MINOR SUBDIVISION PLAN

4 THIRD STREET
LOTS 2.01 & 2.02 BLOCK 24.01

RMPB-R9160

**Re: Minor Subdivision
4 & 4A Third Street; Block 24.01, Lots 2.01 & 2.02; R-5 Zone
Completeness Review, Engineering Review and Fee Determination**

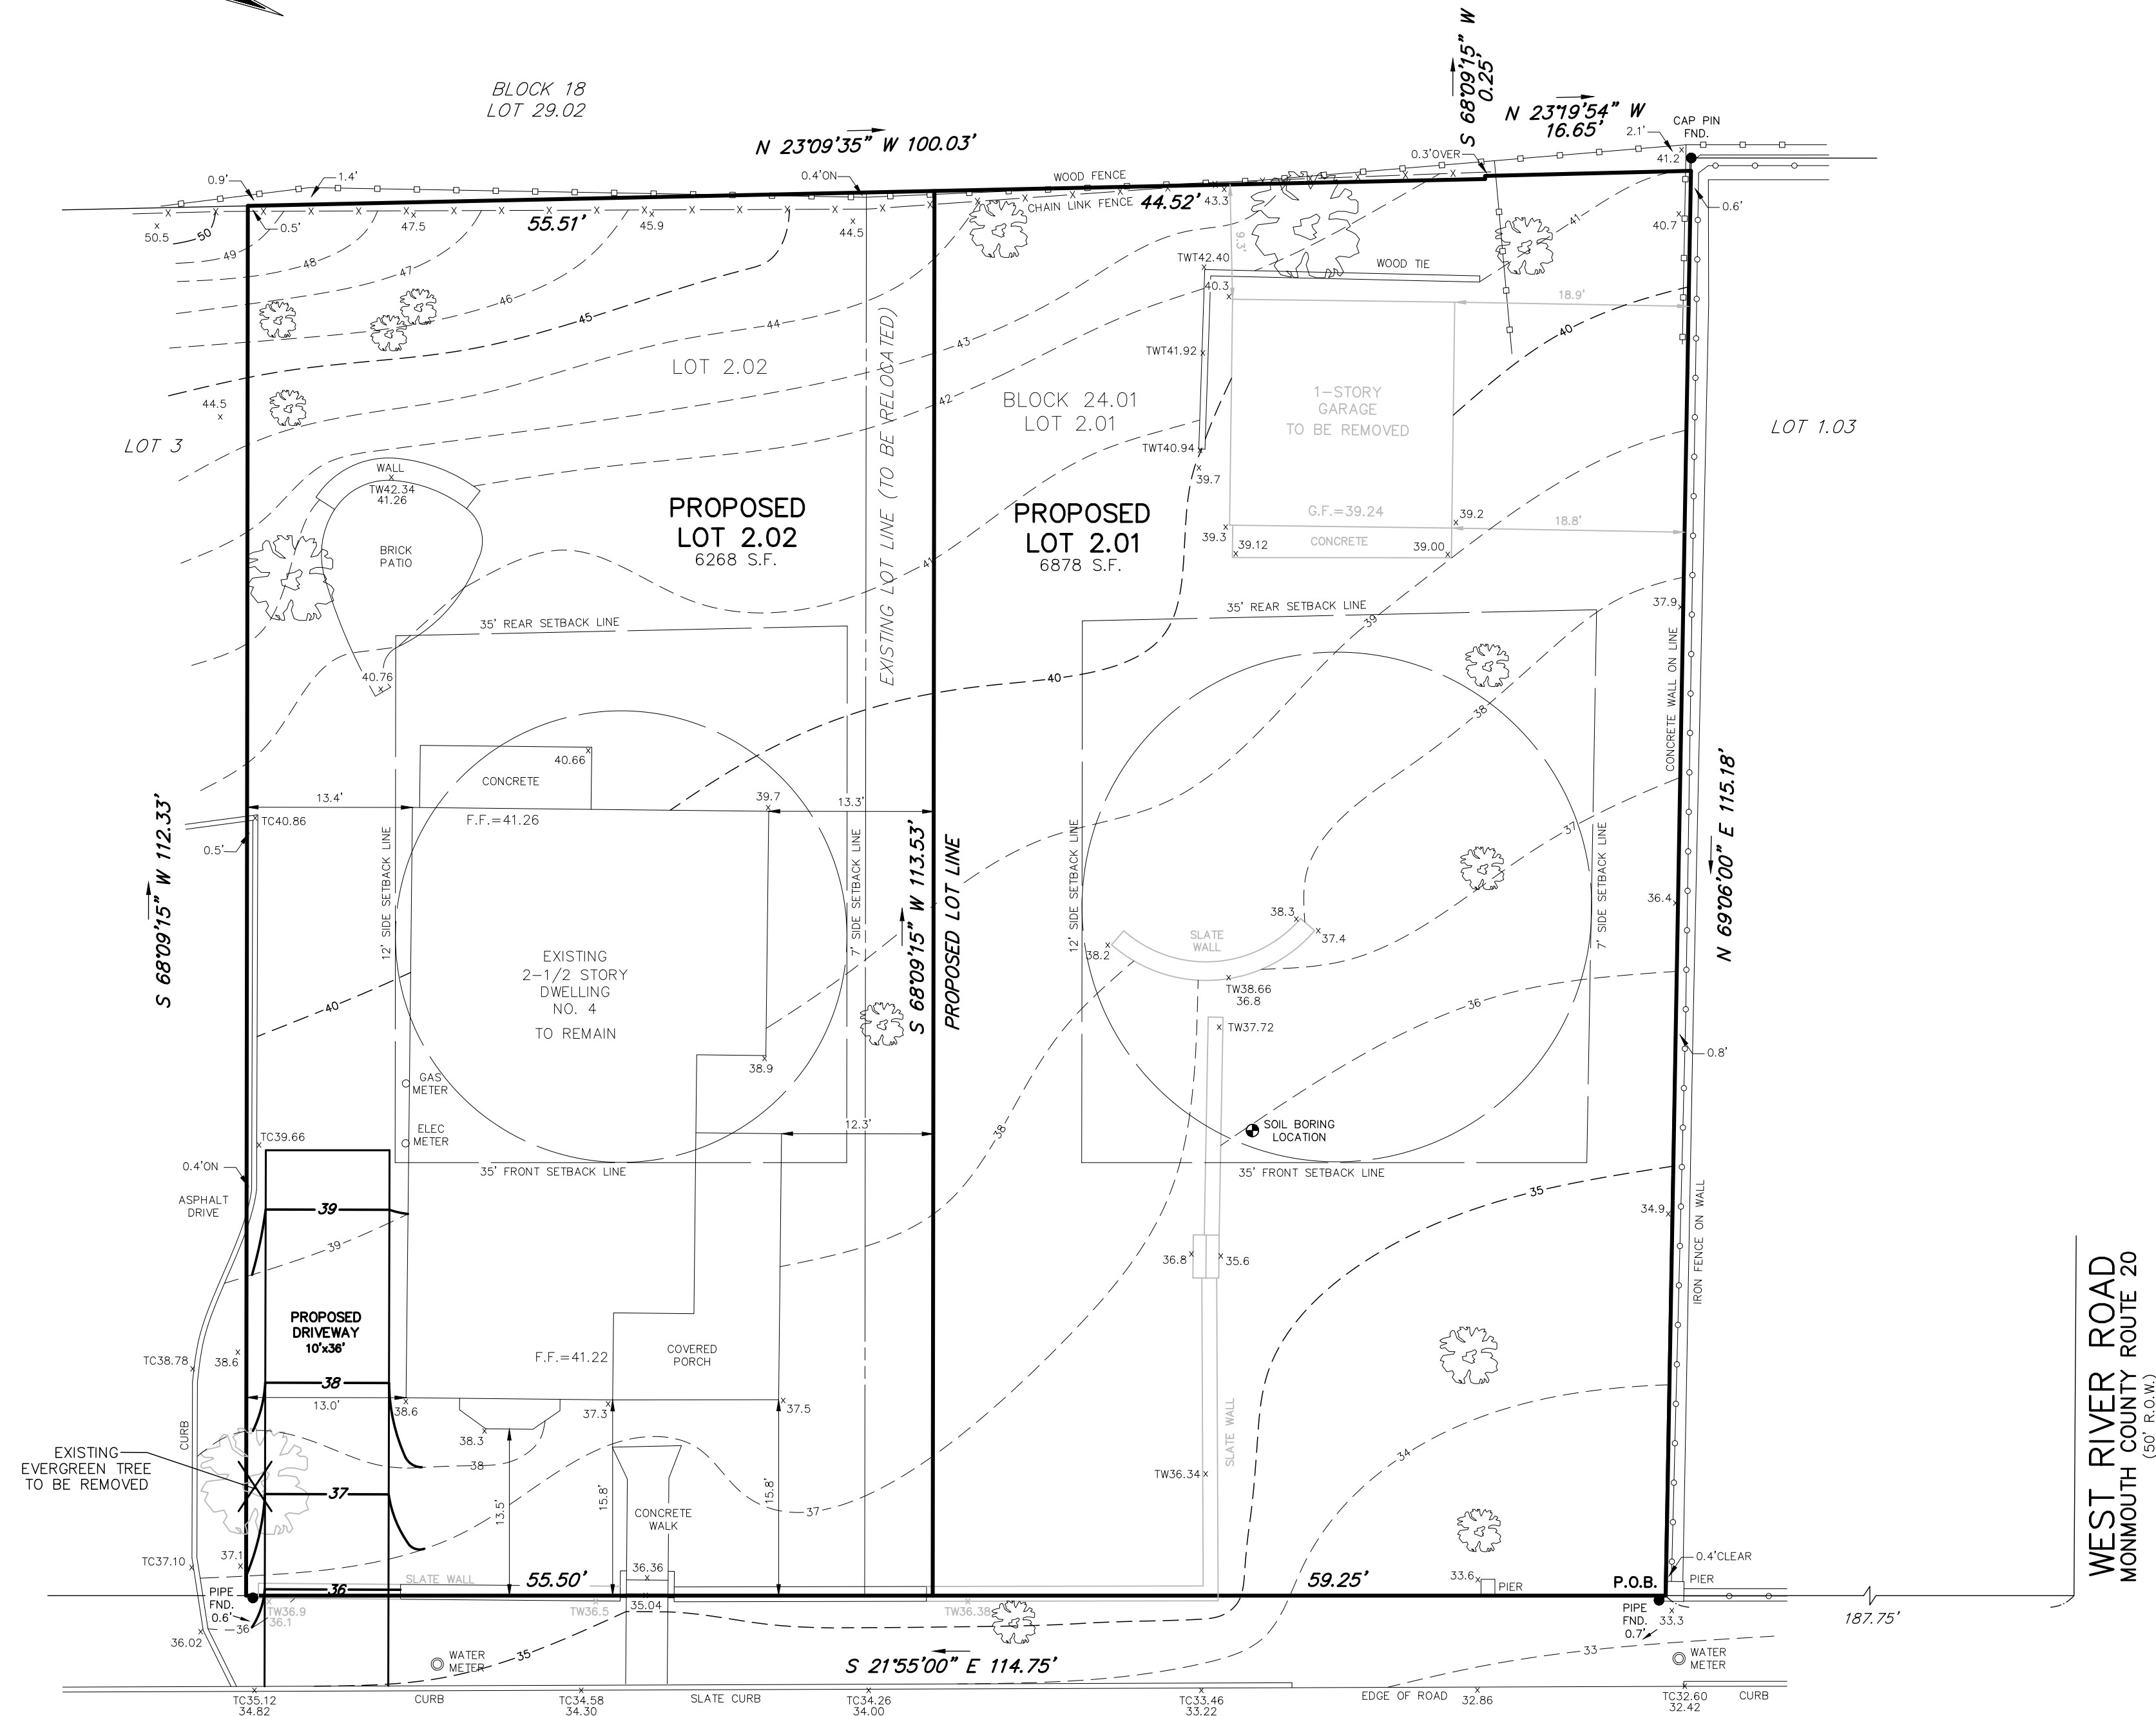
- 1.1 Per Ordinance §22-5.8e. and Schedule 5-1 of the Borough Ordinance, a minimum front yard setback of 35 feet within the R-5 Zoning District, whereas the existing residential dwelling in Lot 2.02 has a front yard setback of 13.5 feet and is proposed to remain. We note that this is a pre-existing non-conforming condition.

- 1.2 The applicant shall clarify the number of bedrooms within the existing dwelling of Lot 2.02 to confirm the number of required parking spaces associated with the dwelling. Tax information indicates a total of 4 bedrooms exist within the dwelling, which would require a total of 3 parking spaces per Ordinance Section 22-5.8.b.1 & 22-9.2.b.1. If 3 parking spaces are required, the driveway shall be extended to include the additional parking space, or a variance may be required.

- 1.3 Per Ordinance §22-9.2b.5.(c), parking shall be located behind the front yard setback line, whereas the applicant proposes a driveway/parking area within the front yard setback. A design waiver will be required.

- 2.1 Revise the single & combined side yard setbacks for proposed Lot 2.02. Per review of the plan, a minimum side yard setback of 12.3 feet and a combined side yard setback of 25.3 feet will be present for Proposed Lot 2.02.

- 2.2 A construction detail shall be provided for the proposed driveway and curb cut in Lot 2.02. Per General Note 15 on the Subdivision Plan, locations and widths shall comply with Borough Ordinance 22-7.26.

- 2.3 General Note 17 indicates all existing improvements are to be removed, whereas the plan indicated only the garage is to be removed. Please clarify.

- 2.4 It is noted that that the survey indicates an encroachment of curb from the adjacent Lot 3's driveway onto Lot 2.02.
- 2.5 General Note 11 on the Subdivision Plan indicates that the proposed subdivision is to be filed by deed. Two (2) copies of the final plans or deeds must be submitted for tax map revisions, as well as to our office and the Board attorney for review and approval. As a condition of approval, the applicant must post the tax map revision fee of \$200 per lot.
